Relevant Information for Local Planning Panel

SUBJECT: Information Relevant To Item 3 – Development Application: 21C Billyard Avenue, Elizabeth Bay – D/2023/727

**SUPPLEMENTARY JOINT EXPERT REPORT ADDRESSING HEIGHT OF BUILDINGS
CALCULATION**

Supplementary Joint Expert Report
Appendix B: Height Plane Amendment

Amended Height Plane - Section Diagram (DA010 F)

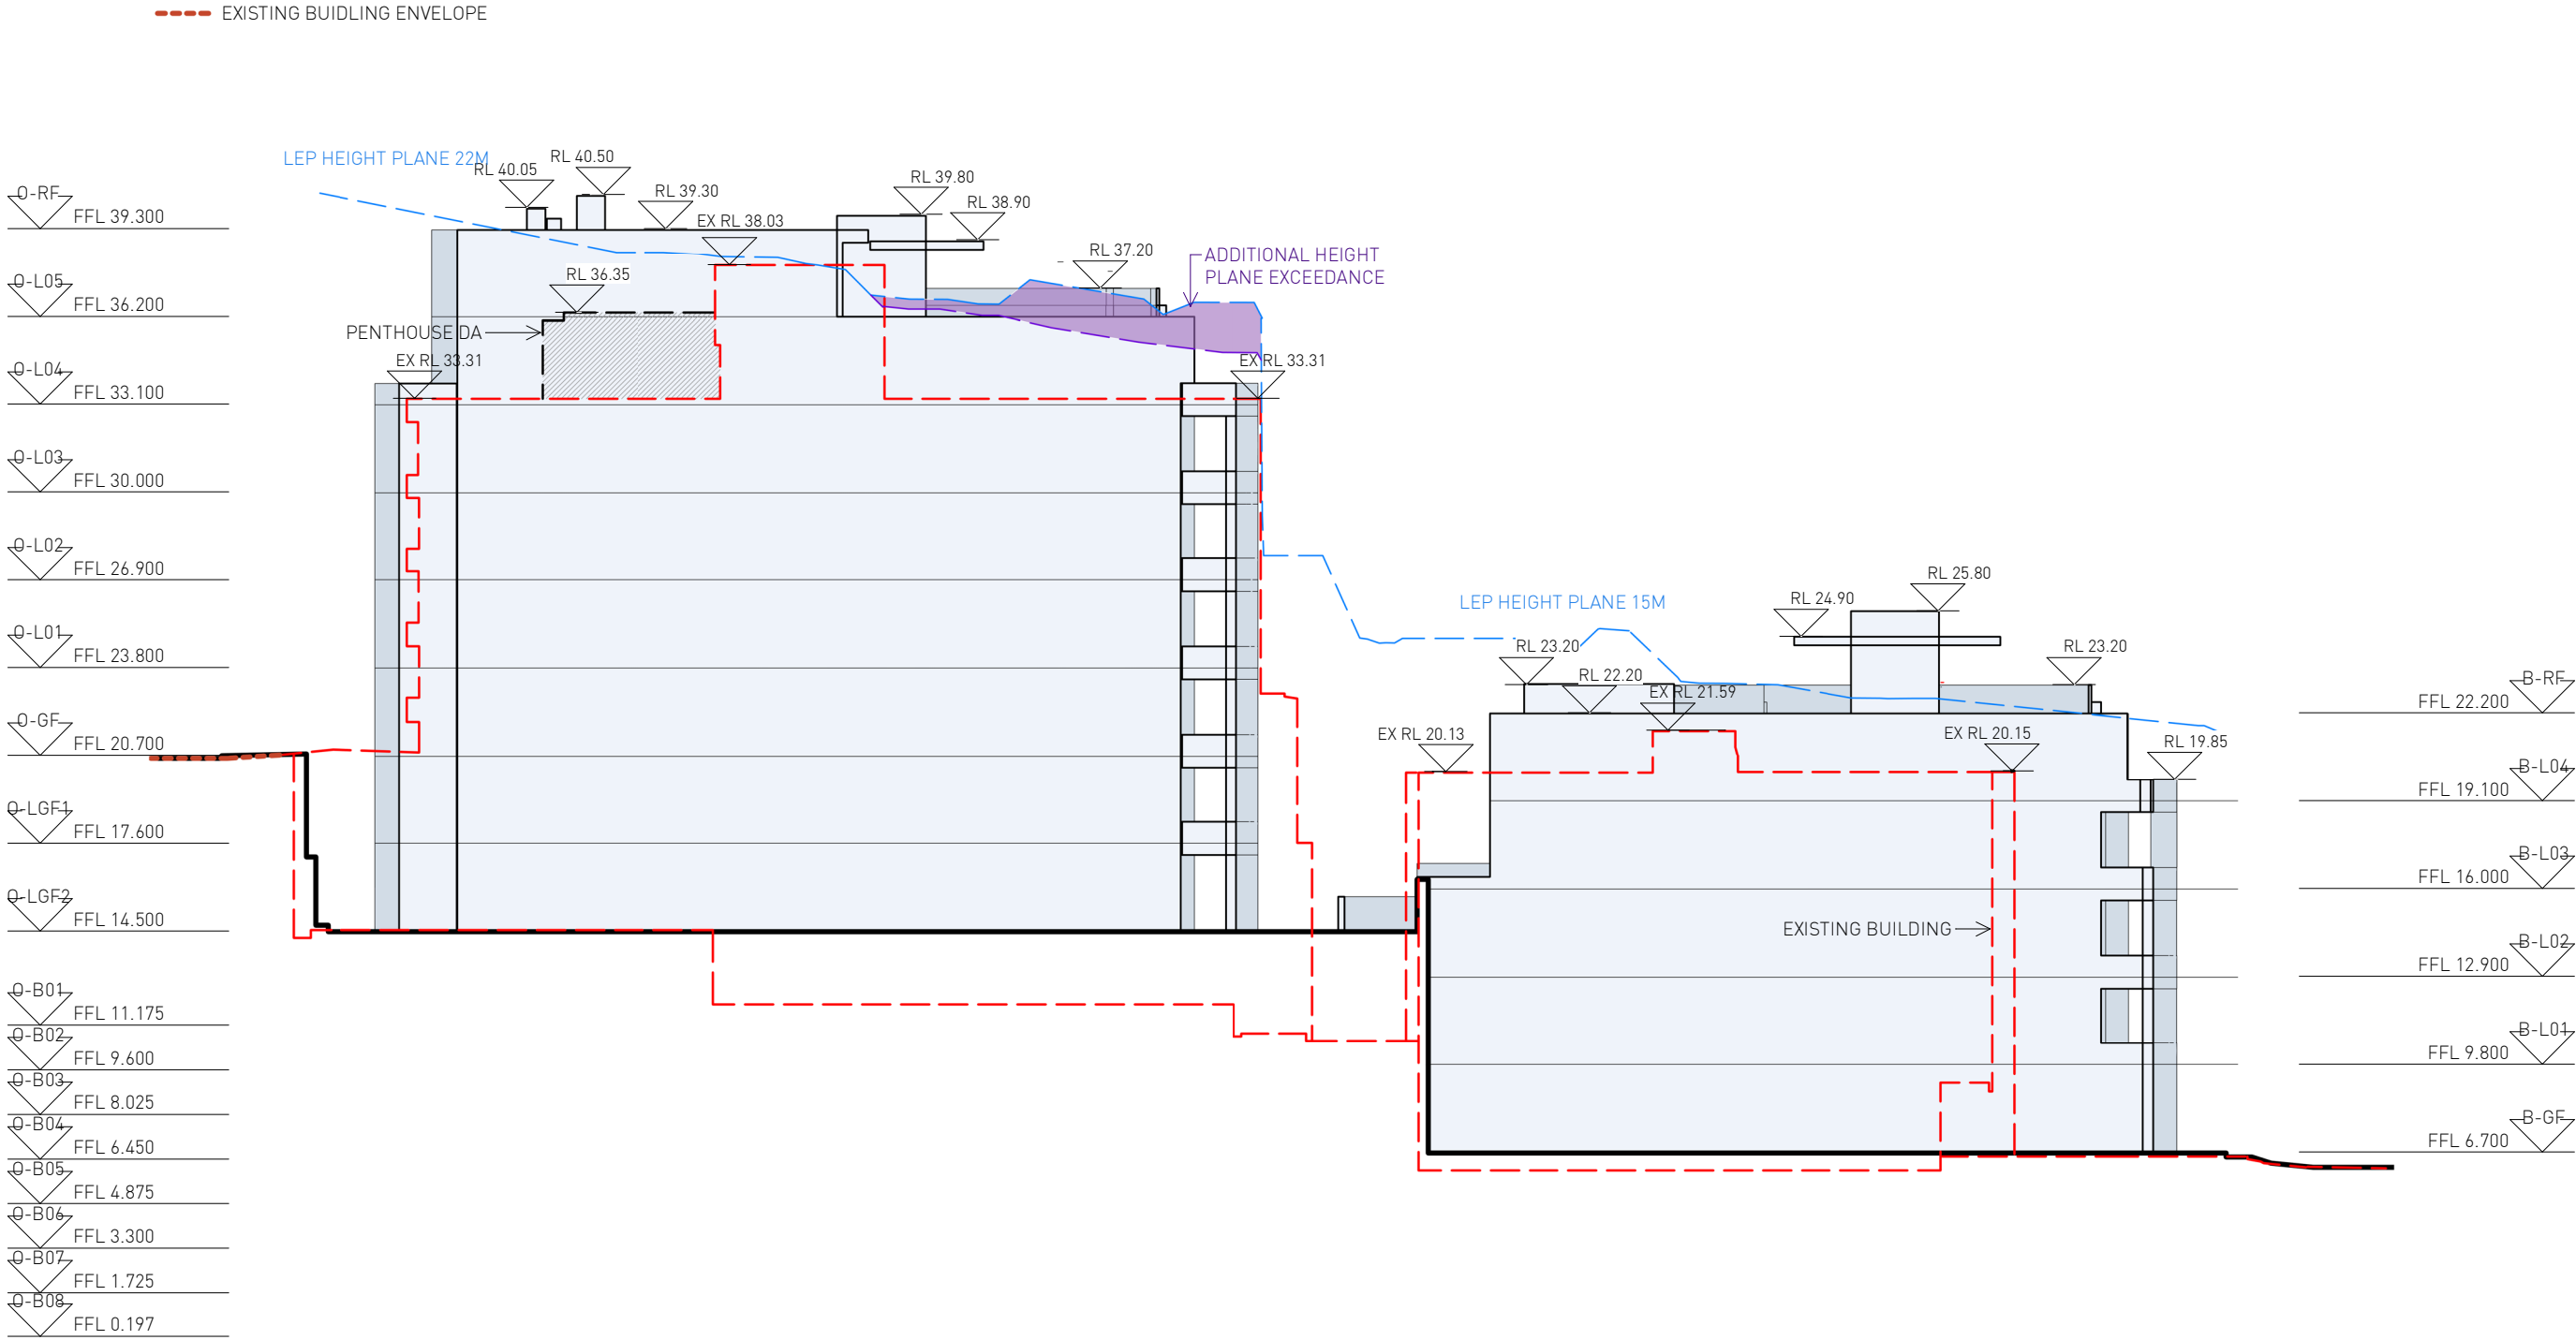
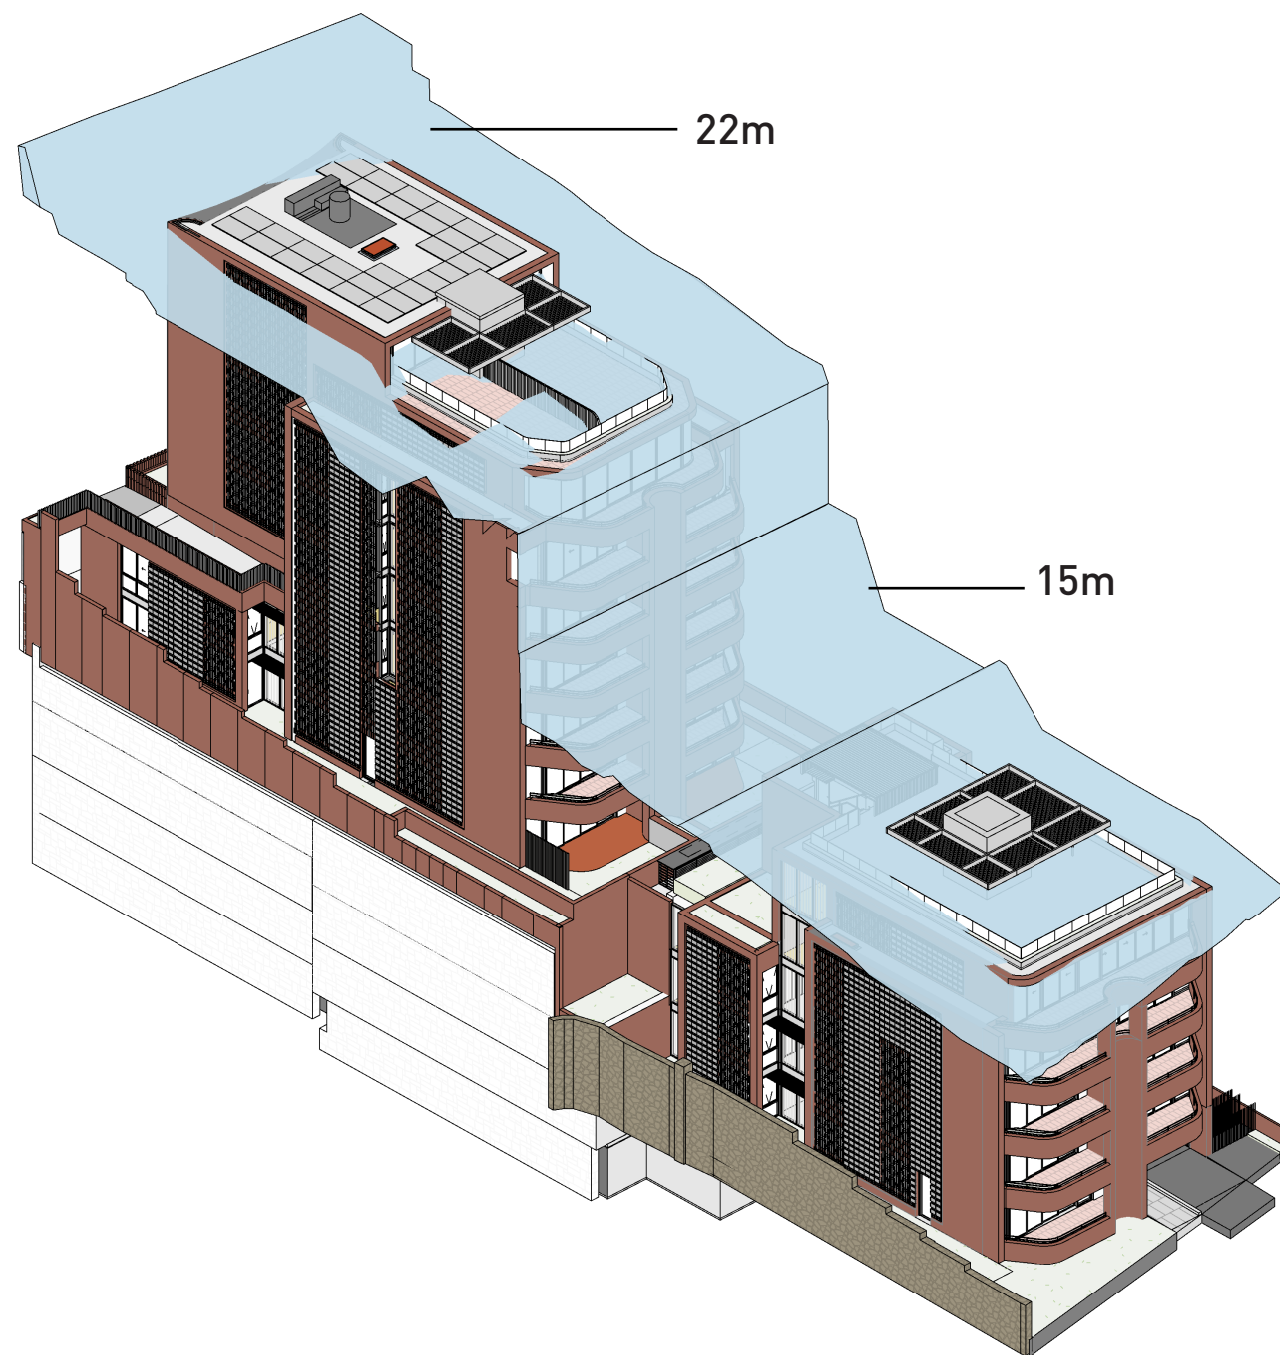
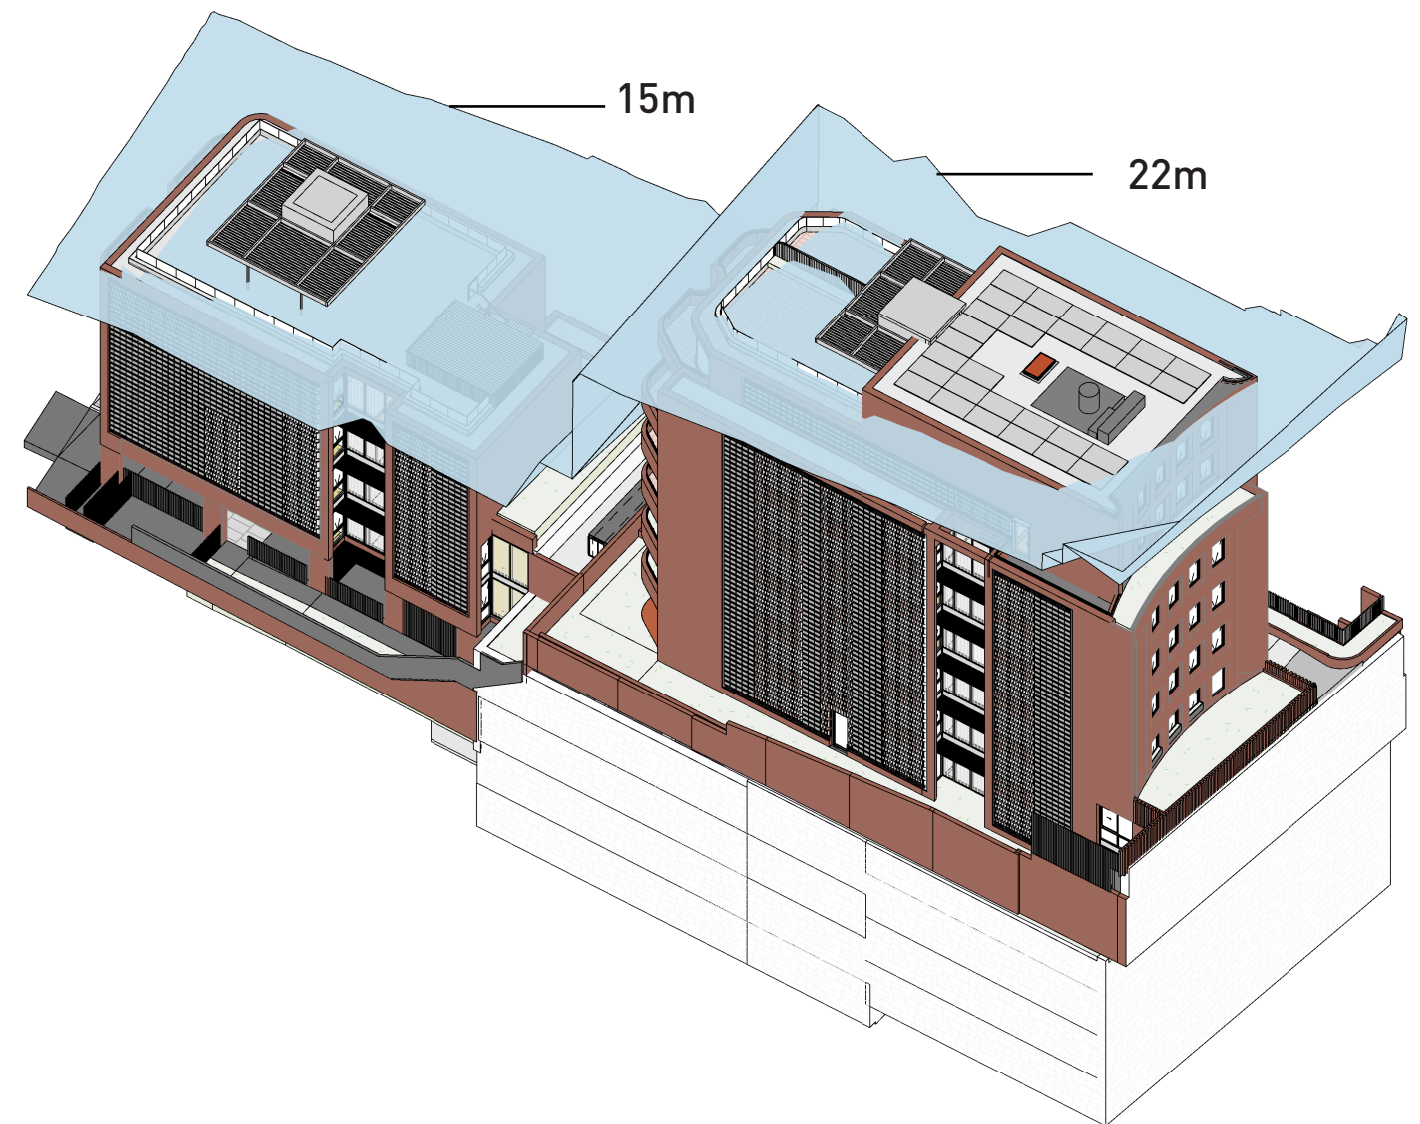
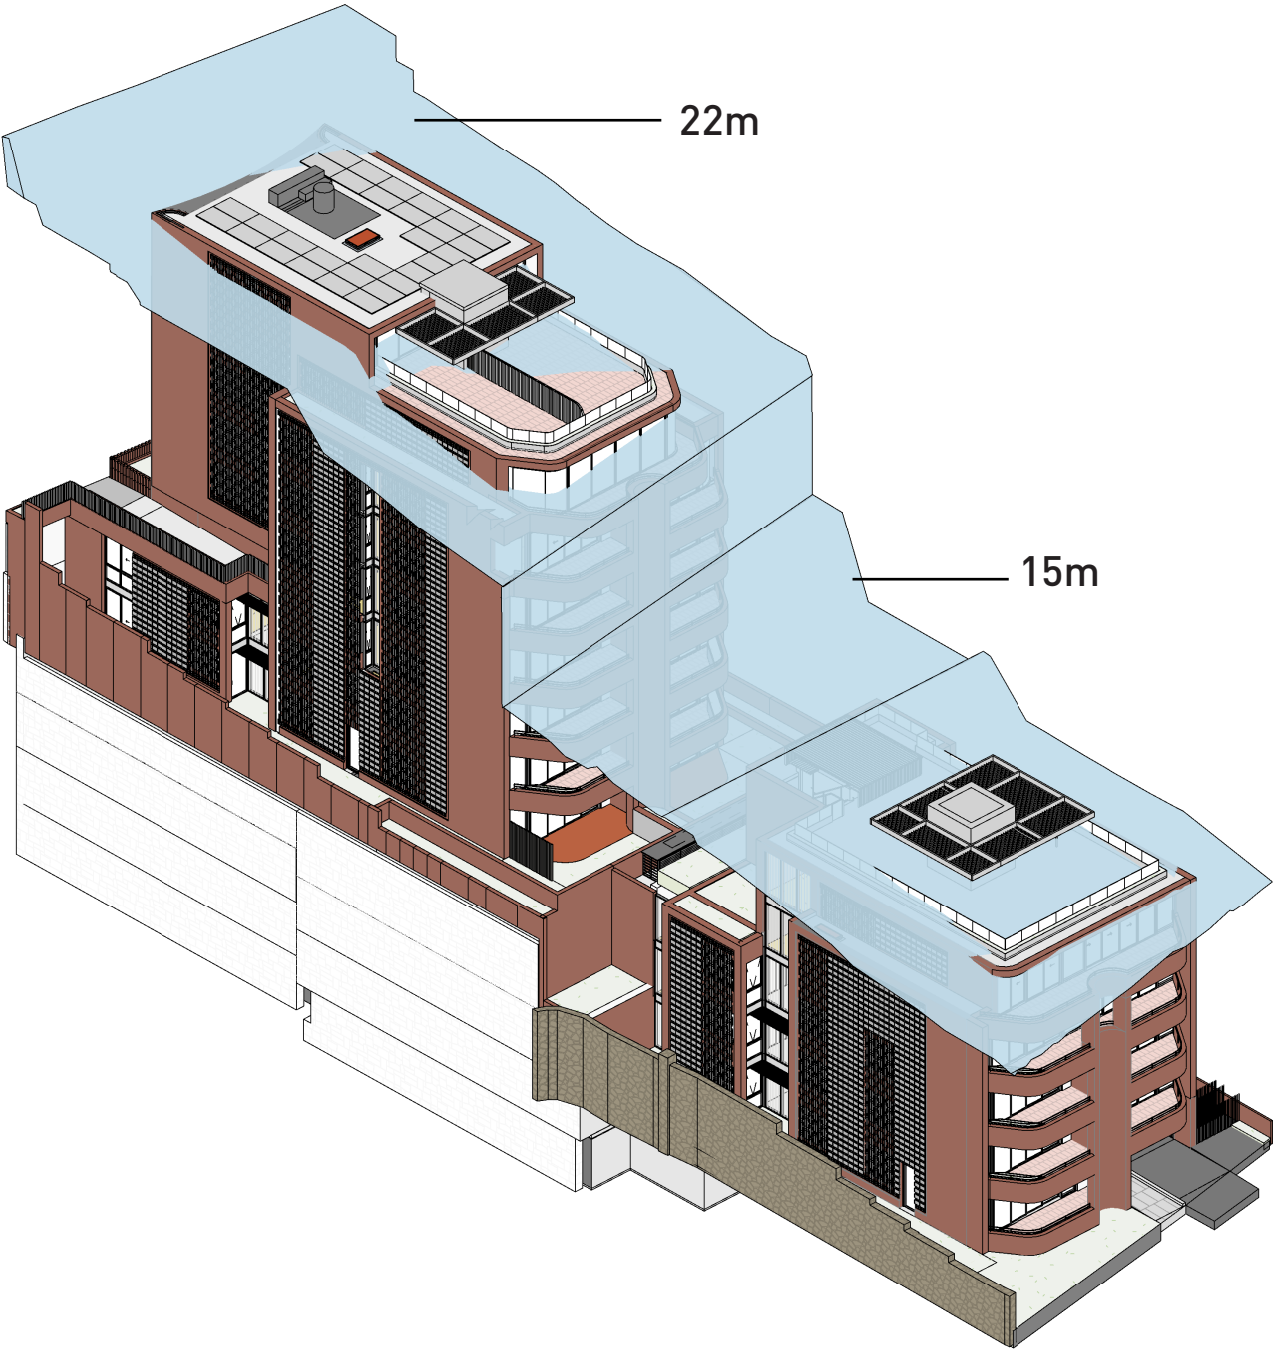
Current: DA Issue 09

Amended
